RE: Proposed 40B Project
Washington Street Homes, Sherborn, MA

RE: Chapter 40B Comprehensive Permit for Washington Street Sherborn

REFERENCE MAP 1

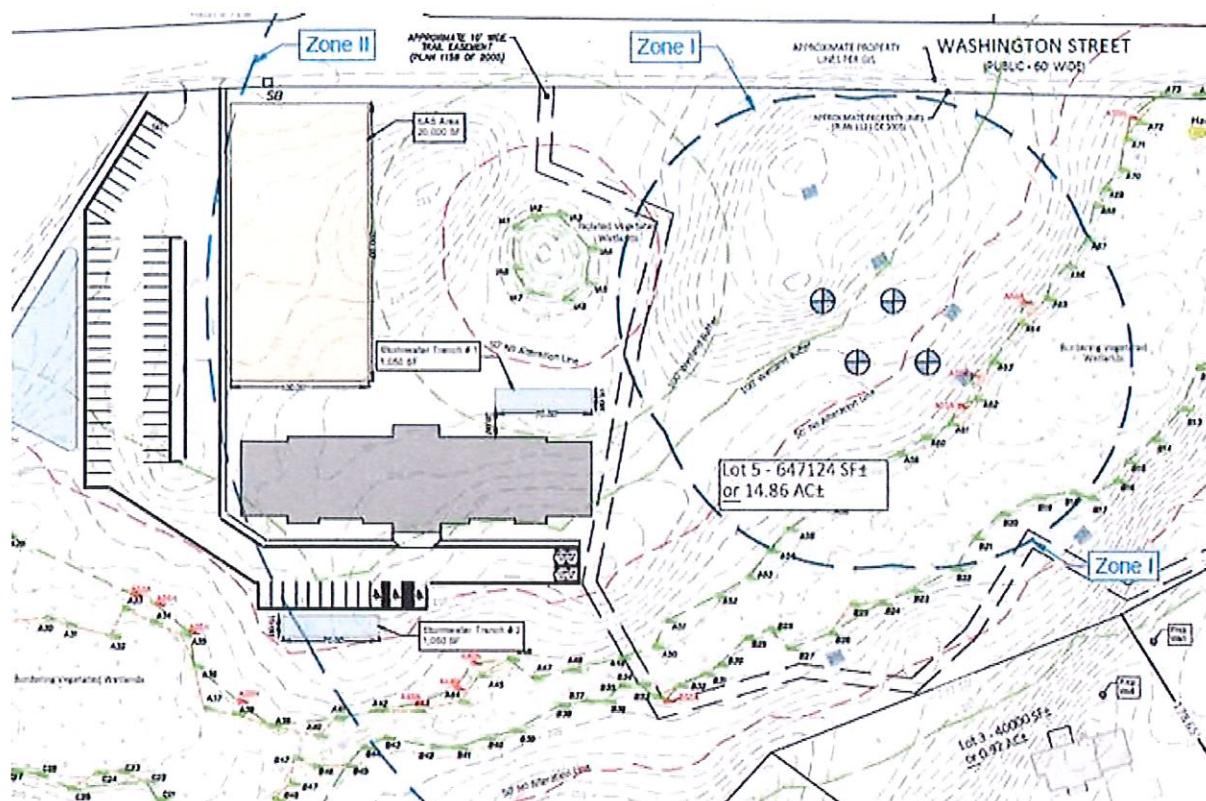
A public well per MassDEP design requirements, serving a flow of up to 7,700 gal/day, calls for a protective Zone 1 radius of about 233 ft around the well, along with a Zone 2 region of about a 570 ft radius. Given the areas represented by these protective zones, non-permitted Zone 1 structures like the large septic leach field would be problematic as shown by the initial site plan map.

private water supply. Proposing multiple (site plan shows 4 wells) private wells to the apartment building appears to be incompatible with the need for a public water supply as regulated under 310 CMR 22.

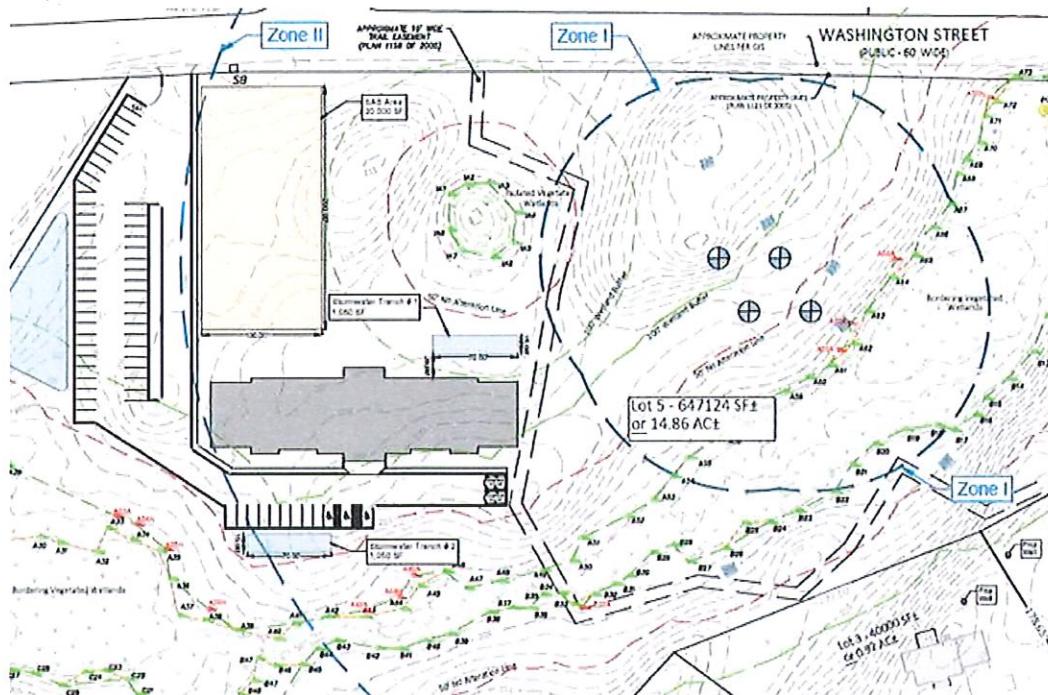
As seen by a portion of the proposed site plan inserted here, the 3-story building and paved parking area are within a few feet of the trail, and stormwater trench # 1 is also nearby. This trail brings many current residents from the areas of Greenwood St, Russet Hill Road, Washington Street, Woodland Road, and additional neighborhoods through this currently undeveloped forested wetland property. Walkers and bike riders traverse this short trail in order to get to the longer Bailey Trail, which has a trail head at the intersection of Washington St (Rt 16) and Old Orchard Road. The addition of the 40 apartment units (70 bedrooms) will increase trail use considerably.
